**CITY OF LA VISTA
MAYOR AND CITY COUNCIL REPORT
SEPTEMBER 18, 2018 AGENDA**

Subject:	Type:	Submitted By:
APPLICATION FOR PUD SITE PLAN – LOT 1, ROTELLA’S FIRST ADDITION, LOTS 4, 5, 6, 15, 16, 17, AND 28A OAKDALE PARK, AND TAX LOT 8A2 (108 TH ST & HARRISON ST)	◆ RESOLUTION ◆ ORDINANCE RECEIVE/FILE	CHRISTOPHER SOLBERG CITY PLANNER

RE: Rotella's Italian Bakery
Site Development Plan
Proposed Planned Unit Development (PUD) Site Plan - Initial Review

RE: Rotella's Italian Bakery
Site Development Plan
Proposed Planned Unit Development (PUD) Site Plan – 2nd Review

CURRENT TRAFFIC DIAGRAM
NEIGHBOR / LOCAL TRAFFIC
BREAD STORE TRAFFIC (CARS)

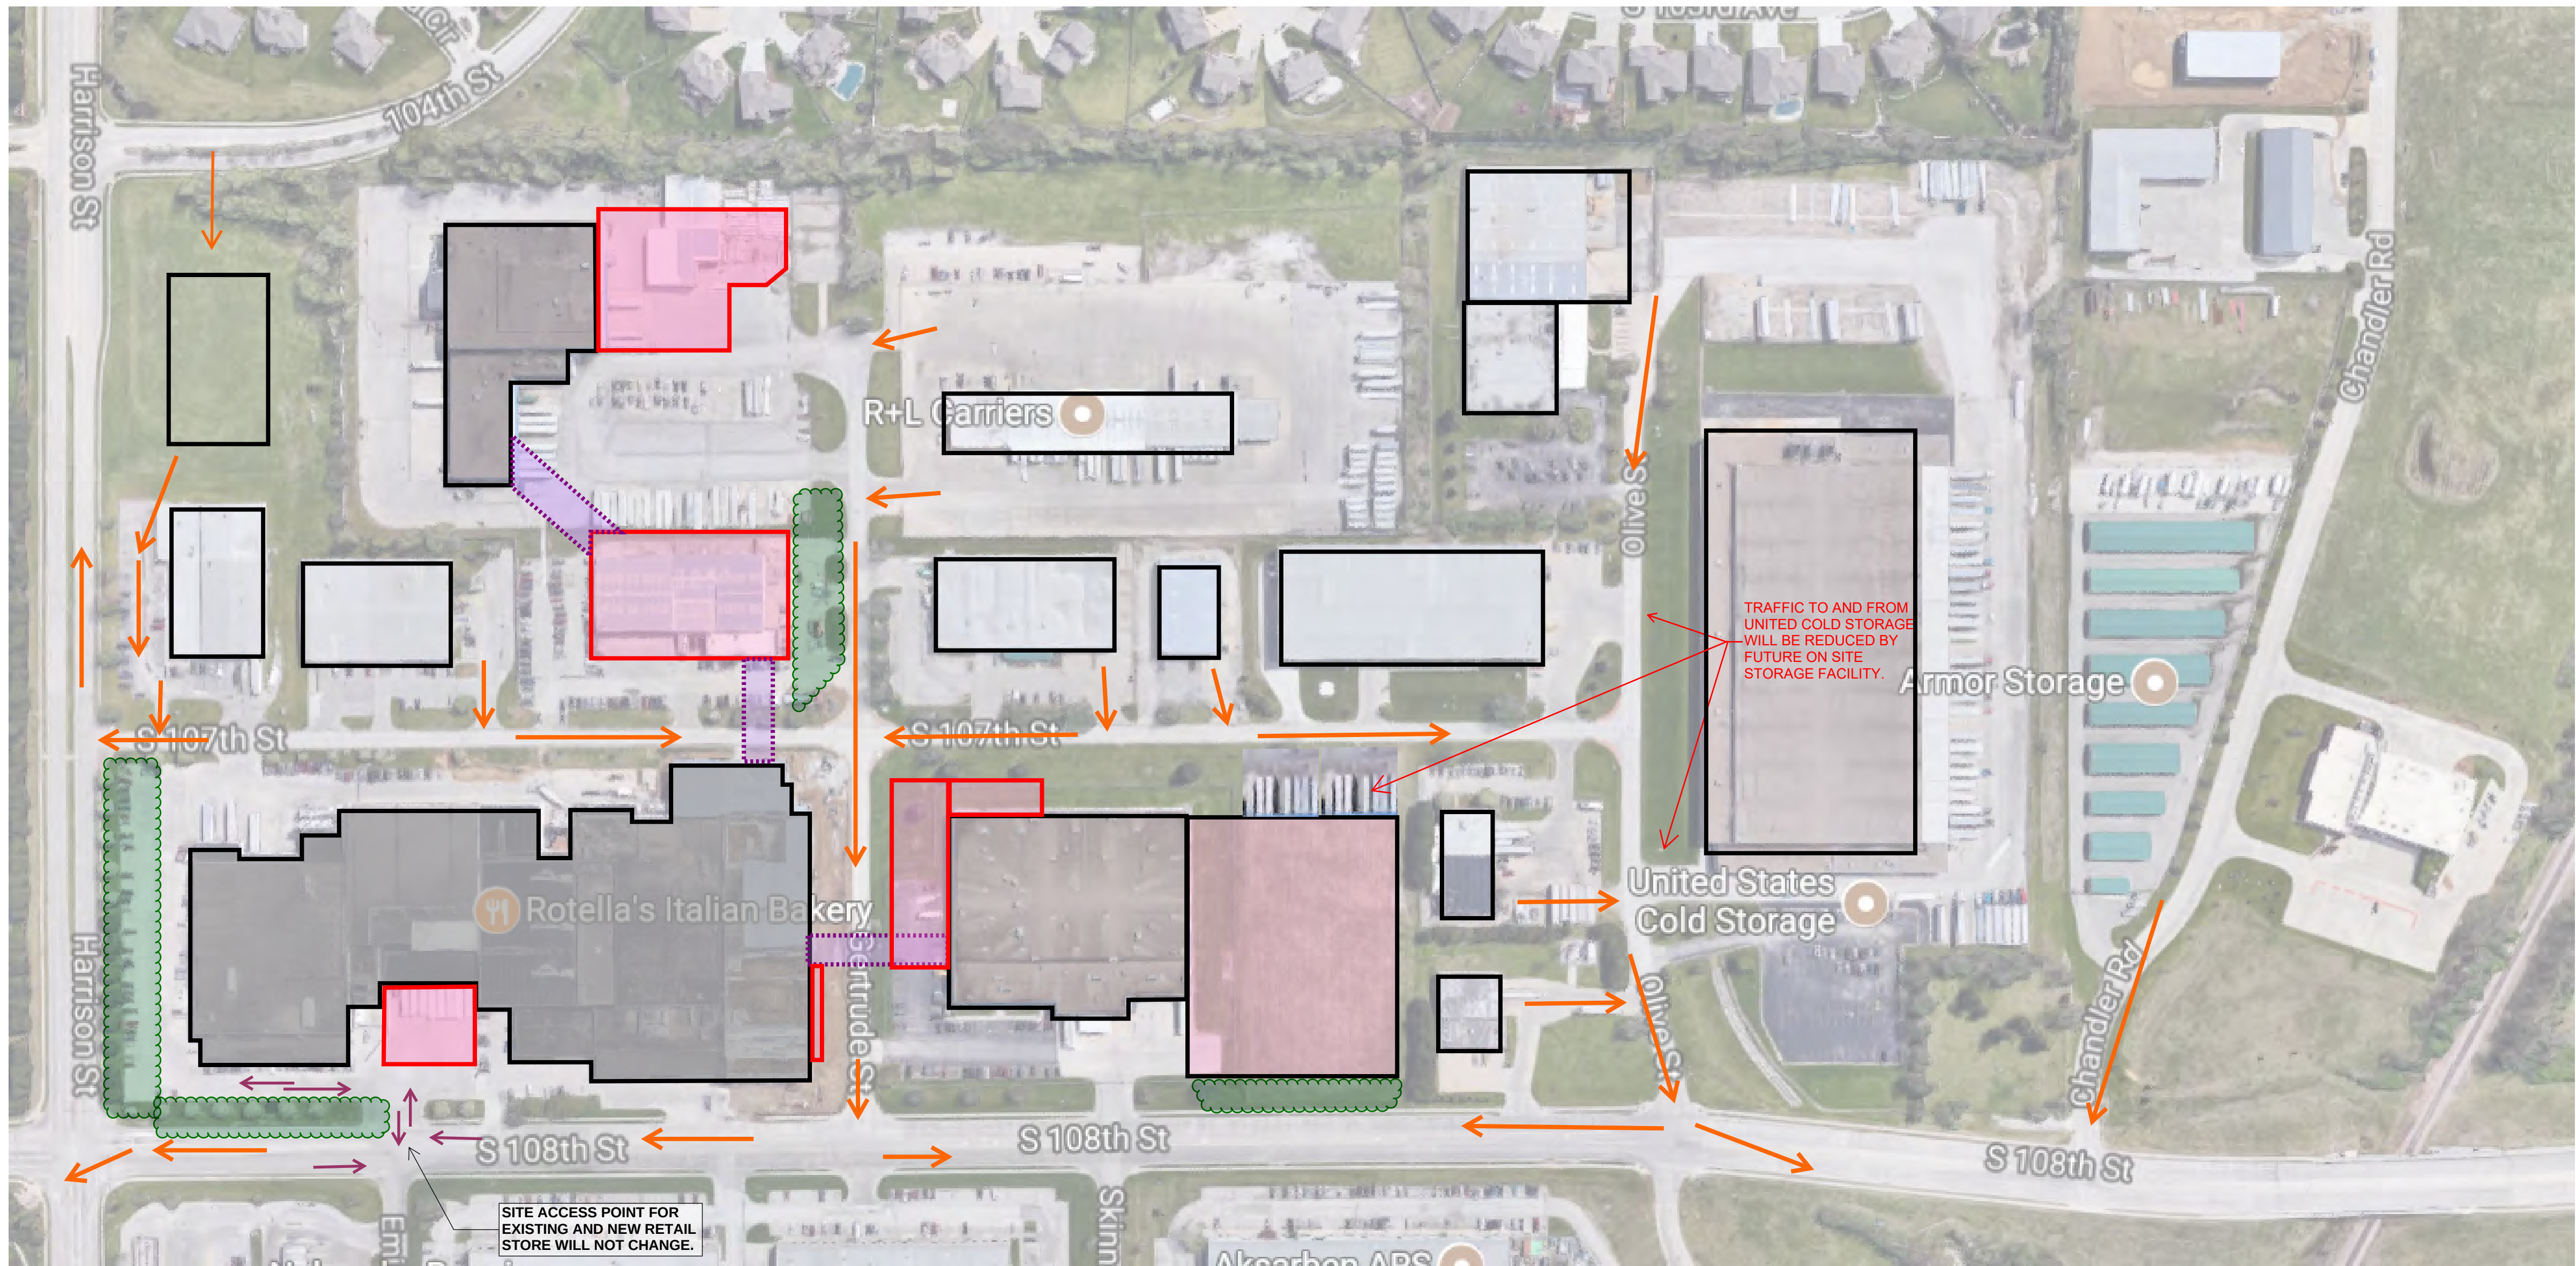
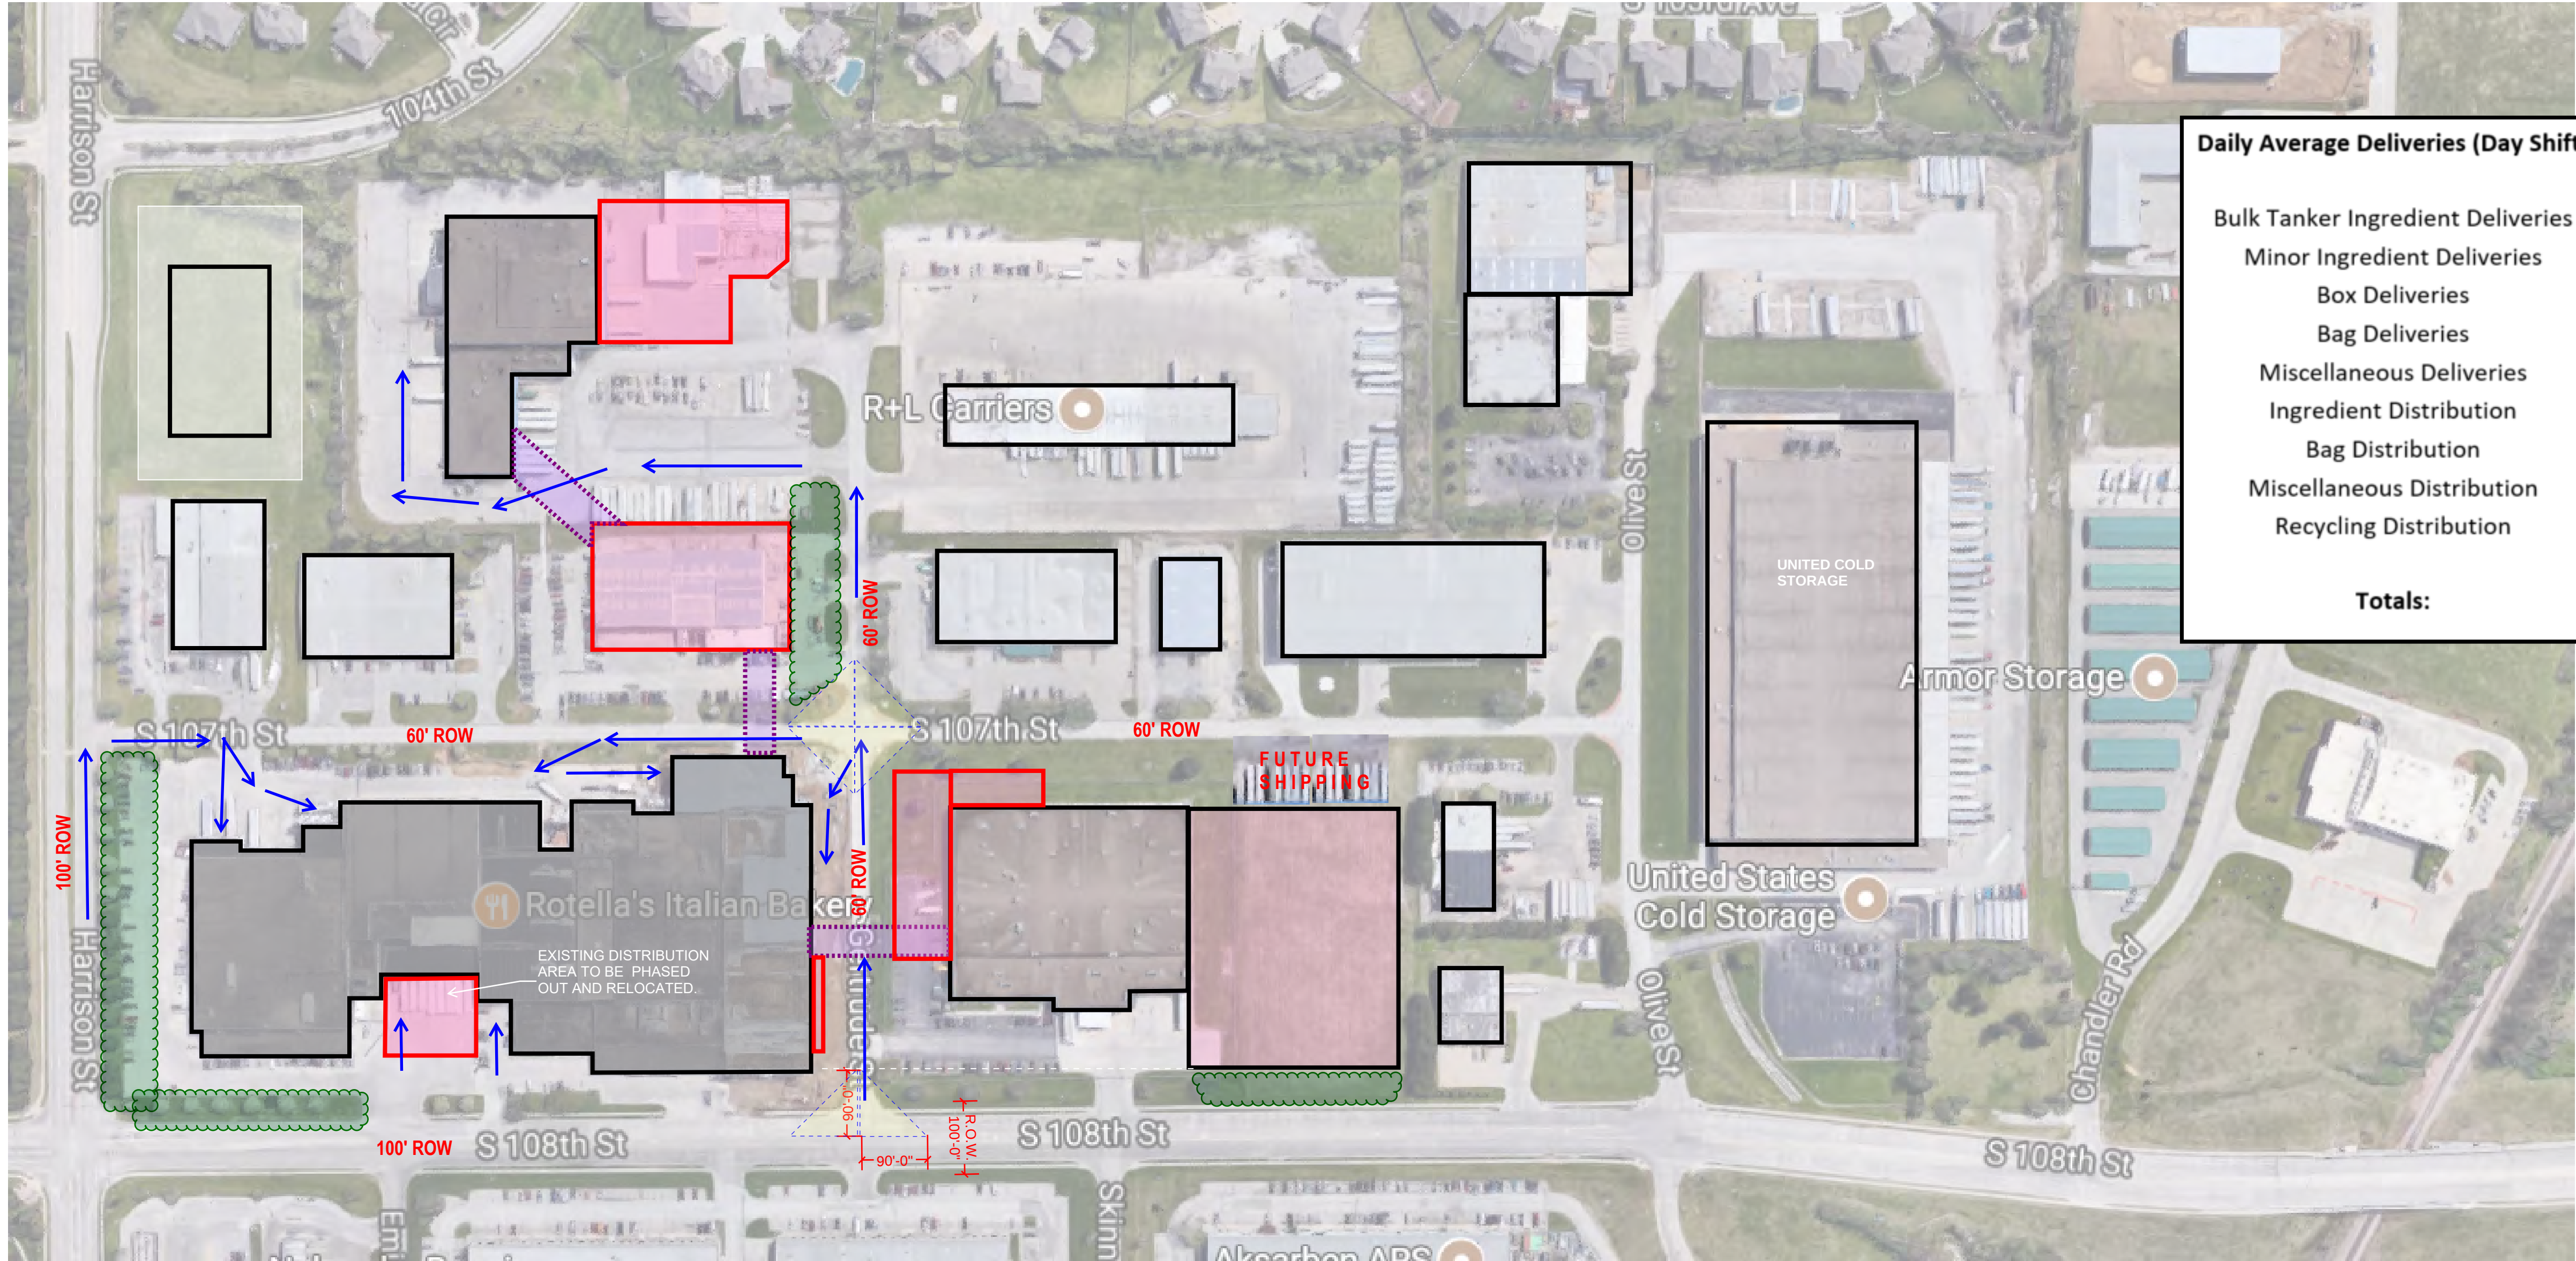
4. Article 5.15.04.03: Attachments 6 and 7 in the PUD binder present information on existing truck traffic between buildings, inbound supplies, and outbound products. In order to determine the adequacy of roadways to serve the development additional information is needed. The truck count information that is provided in Attachments 6 and 7 should be updated to include projected volumes at the end of Phase A5. The PUD plan should address whether the local delivery trucks will be using a different access point than the current driveway onto 108th Street. There needs to be information as to traffic generated by the retail operation now and in the future and the access points to be used by the retail traffic. The peak hour volumes and times related to the retail operation are needed. When this information is provided, we can determine if a traffic impact study may be required at some future point in the development of this PUD plan.

- i) Comment: Revise Attachments 6&7 to show projected truck volume at end of Phase 5.
- ii) Response:

- (1) Outbound truck traffic is of two type: Local route delivery trucks and long distance semi traffic.
 - (a) Local delivery route trucks (20 per day) are not expected to change in the near term. One of the last phases will involve consolidation of shipping, adjacent to the future cold storage facility. At that time some of the route truck would likely move from 108th street.

- (3) See **Table 3D** for traffic recap, and a site diagram of future truck traffic patterns has been added.
